ADDENDUM NO.	1 DATED	6/21/201	7 ADDEN	NDUM NO.	DATED	
ADDENDUM NO	DATED			NDUM NO.		
	Description o. 907-107-1; Revised o . 8001, 8002, & 8012; Arr	or Added hendment	TOTAL ADD (Must agree w Respectfully S DATE BY TITLE ADDRESS CITY, STATE PHONE FAX	ENDA: <u>1</u> rith total addenda Submitted, C S E, ZIP	ontractor	
(To be filled in if a corpo	ration)					
· •	is chartered under the					and the names,
Presi	dent			А	ddress	
Secre	etary			А	ddress	
Treas	surer			А	ddress	
The following is my (our BR-0056-01(093)/ 1 Hinds & Rankin Co	07404301000 & BR-0	056-01(093)/	10740430200	00

### **SPECIAL PROVISION NO. 907-107-1**

### SUBJECT: Contractor's Erosion Control Plan

## ADDENDUM

SHEET NUMBER 8001 8002

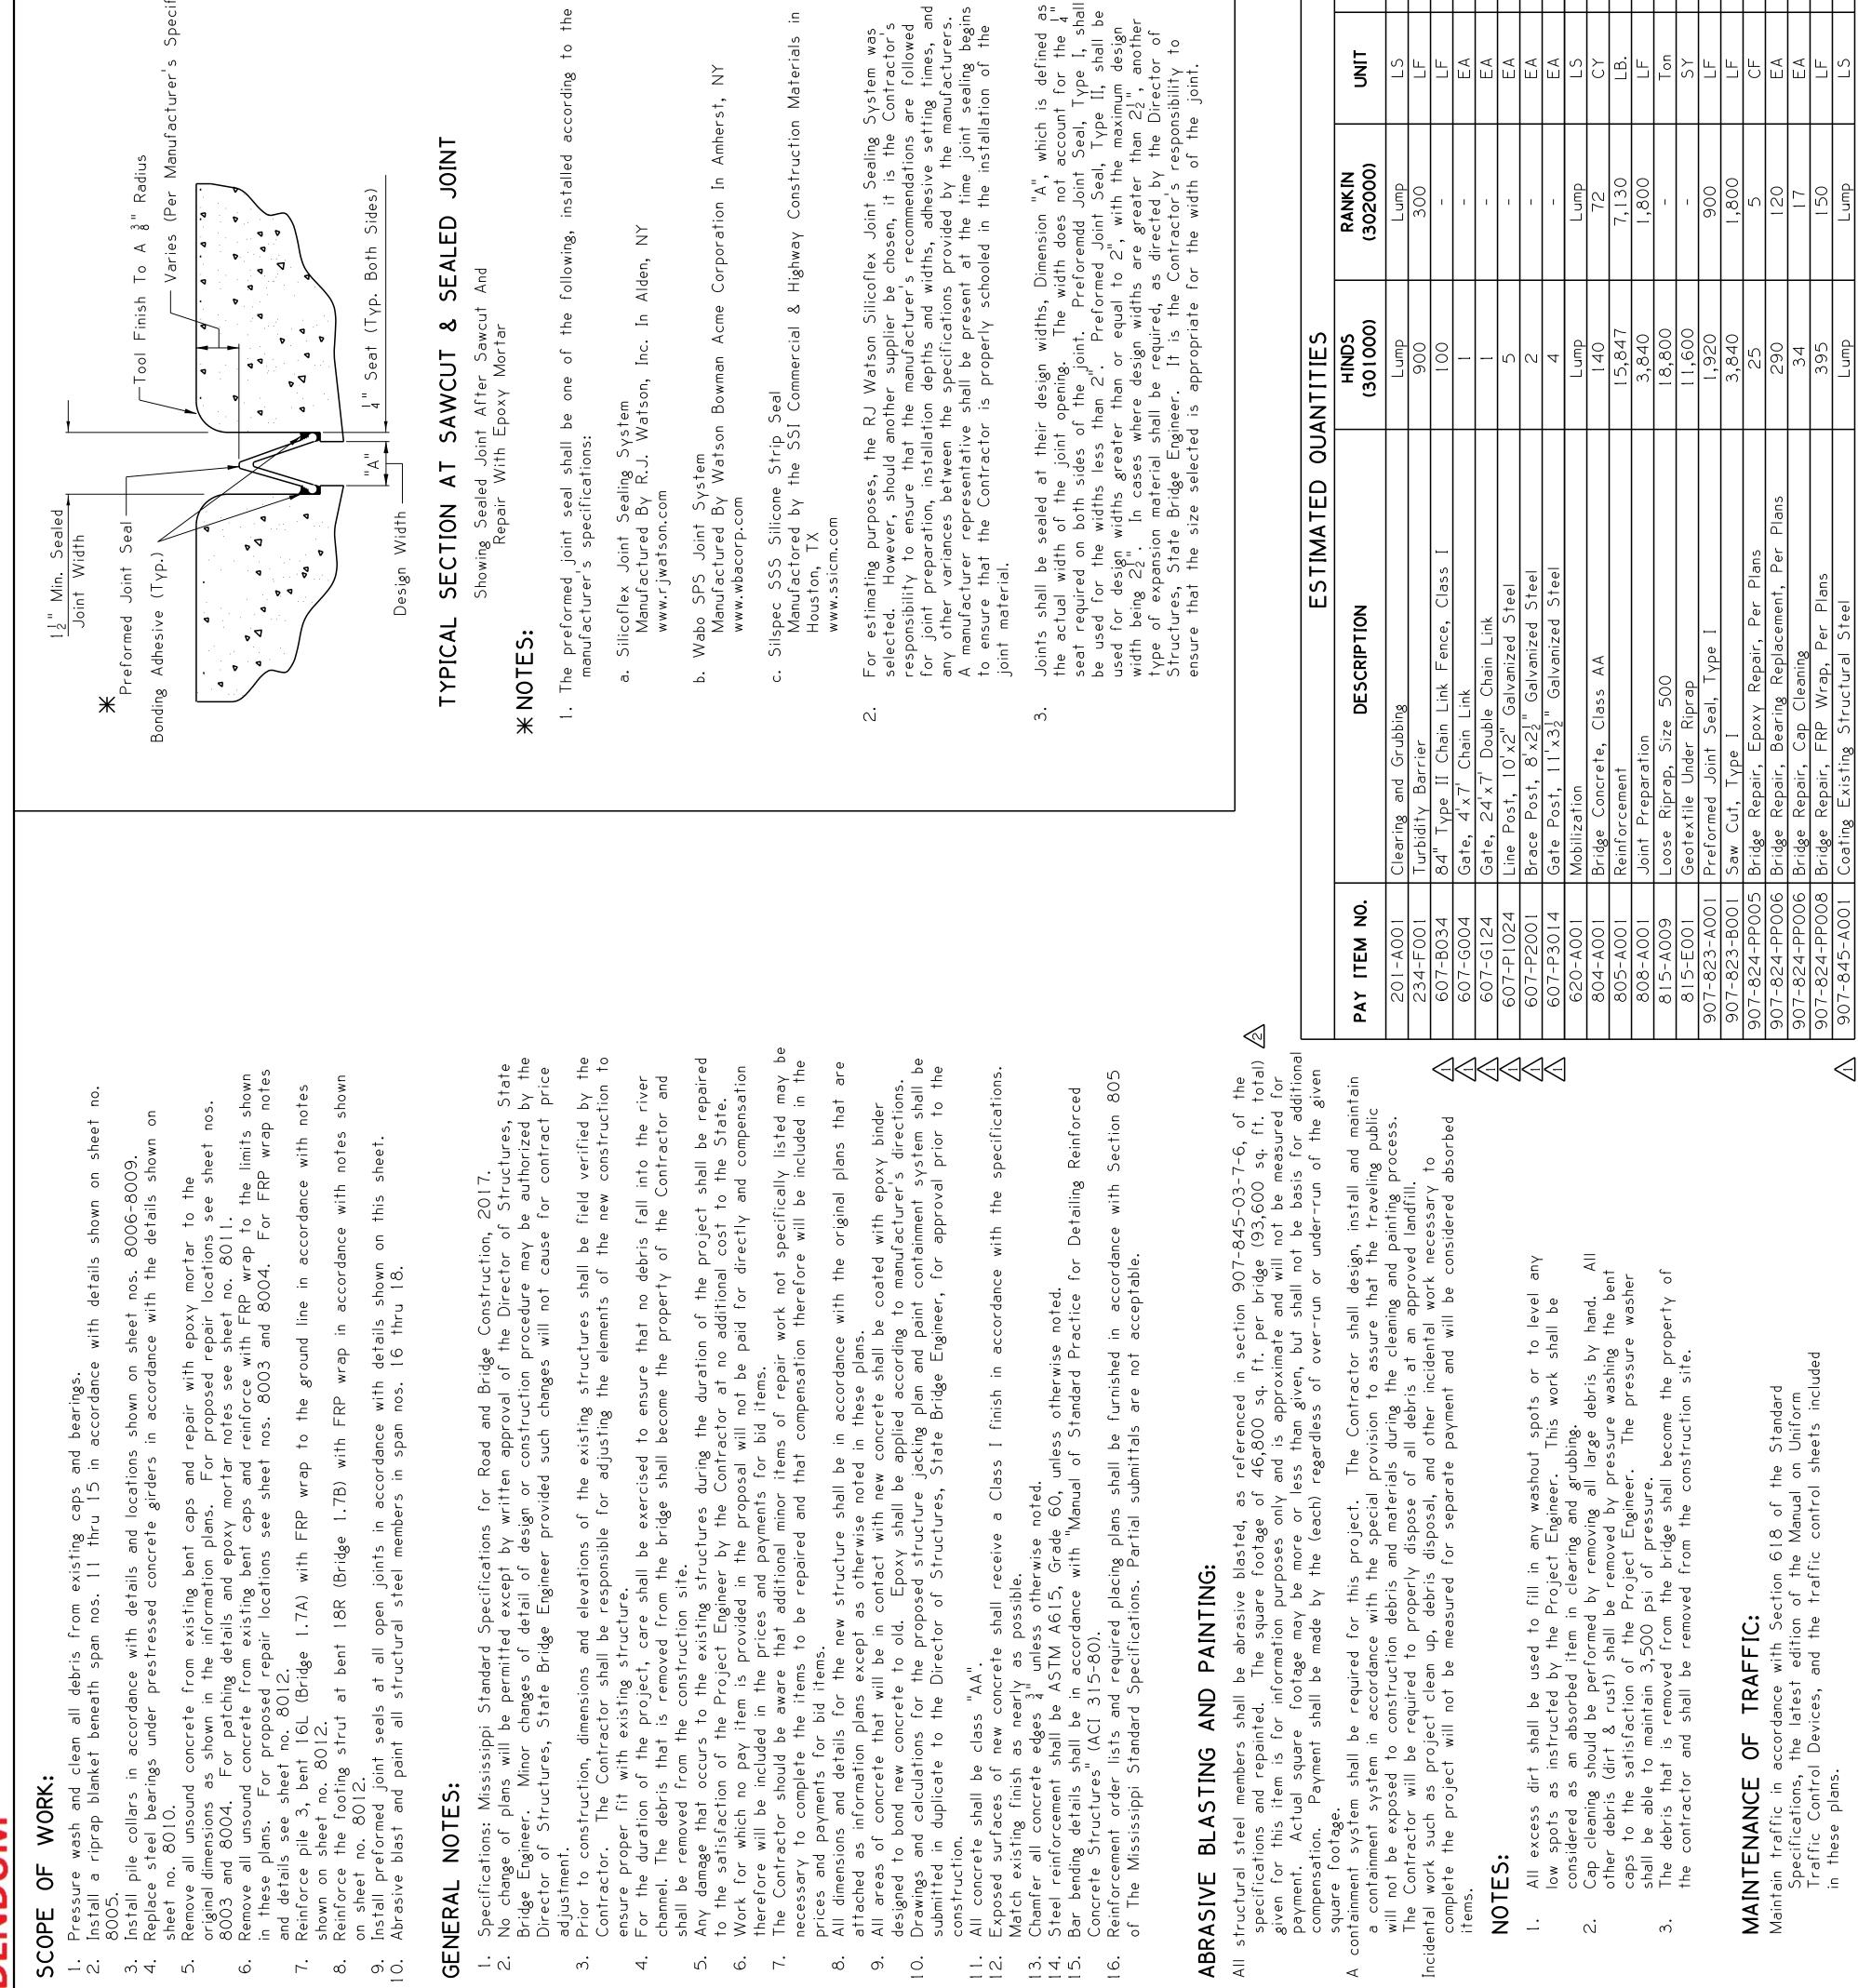
- and bearings. in accordance with details shown on caps u 15 Pressure wash and clean all debris from existing ca Install a riprap blanket beneath span nos. 11 thru 8005. Install pile collars in accordance with details and lo -. ~.

- 8006-8009.  $\omega$  4.
  - с.
- Bistall pile collars in accordance with details and locations shown on sheet nos. 8006-8009.
   Replace steel bearings under prestressed concrete girders in accordance with the details shown sheet no. 8010.
   Remove all unsound concrete from existing bent caps and repair with epoxy mortar to the original dimensions as shown in the information plans. For proposed repair locations see sheet n 8003. and 8004. For patching details and epoxy mortar notes see sheet no. 8011.
   Remove all unsound concrete from existing bent caps and repair with ERP wrap to the limits in these plans. For proposed repair locations see sheet no. 8011.
   Remove all unsound concrete from existing bent caps and reinforce with FRP wrap to the limits in these plans. For proposed repair locations see sheet no. 8012.
   Remove all unsound concrete from existing bent caps and reinforce with FRP wrap to the ground line in accordance with notes and details see sheet no. 8012.

Reinforce pile 3, bent IGL (Bridge 1.7A) with FRP wrap to the ground line in accordance with notes shown on sheet no. 8012.
   Reinforce pile 3, bent IGL (Bridge 1.7A) with FRP wrap to the ground line in accordance with notes on sheet no. 8012.
   Reinforce pile 3, bent IGL (Bridge 1.7A) with FRP wrap to the ground line in accordance with notes on sheet no. 8012.
   Reinforce pile 3, bent IGL (Bridge 1.7A) with FRP wrap to the ground line in accordance with notes on sheet no. 8012.
   Reinforce pile 3, bent IGL (Bridge 1.7A) with FRP wrap to the ground line in accordance with notes on sheet no. 8012.
   Reinforce the footing strut at bent 18R (Bridge 1.7B) with FRP wrap in accordance with notes on sheet no. 8012.
   Reinforce the footing strut at bent 18R (Bridge 1.7B) with FRP wrap in accordance with notes on sheet no. 8012.
   Install preformed joint seals at all open joints in accordance with details shown on this sheet. . 0
